AMERICAN FOREST  
MANAGEMENT

**ARBORIST REPORT**  
**3453 74<sup>th</sup> Ave SE**  
**Mercer Island, WA**

**Updated 5/5/2020**

**1/7/2021 - Revisions to Address City Arborist Comments Dated 10/30/2020**

**TESC PLAN**  
**3453 74TH AVE SE**  
**JIMMY & SHANNON FOO**  
 2020 29TH AVE W  
 SEATTLE, WA 98199

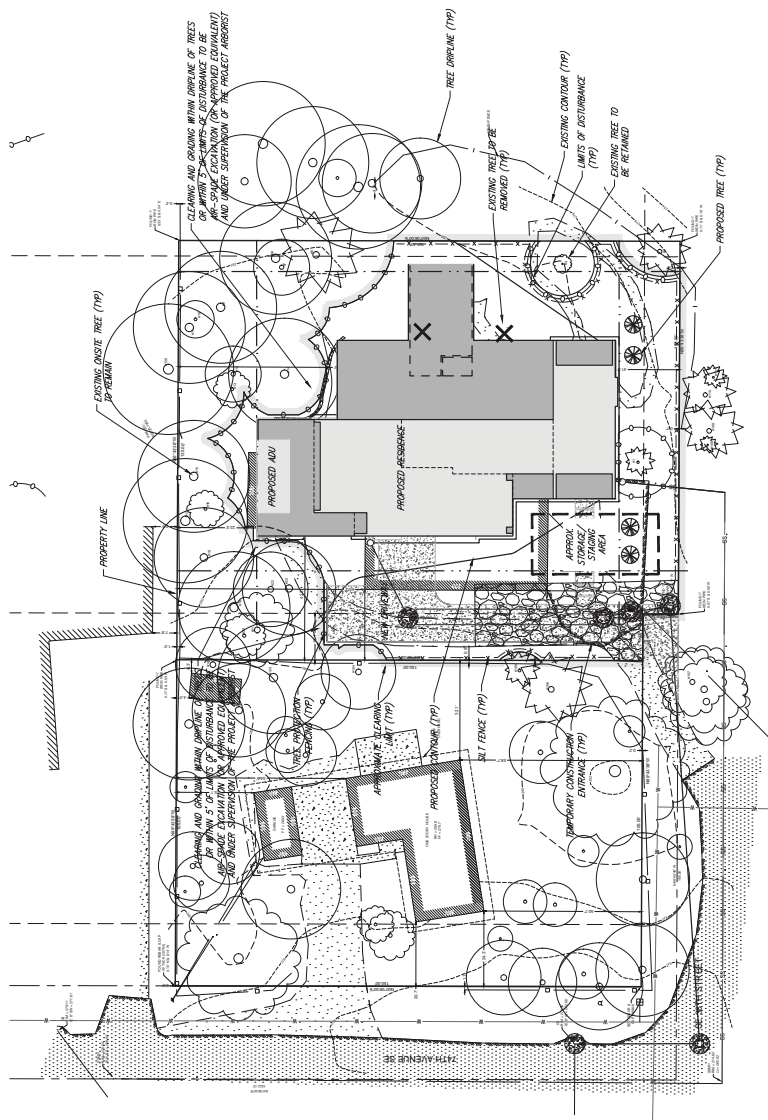
**Trees 14, 18, 22, and 23 will likely have their limits of disturbance encroached by the proposed ADU. Based on the site plan dated 1/7/21, these impacted trees can likely be successfully retained as viable trees if all recommendations, root disturbance, and tree protection measures are adhered to through all phases of development activity. Any incursions into limits of disturbance should be avoided whenever possible.**

**If possible, pneumatic excavation should be carried at the limits of disturbance where proposed improvements encroach within either the drip line or limits of disturbance of retained trees. Air excavation should be monitored and assessed by a qualified arborist.**
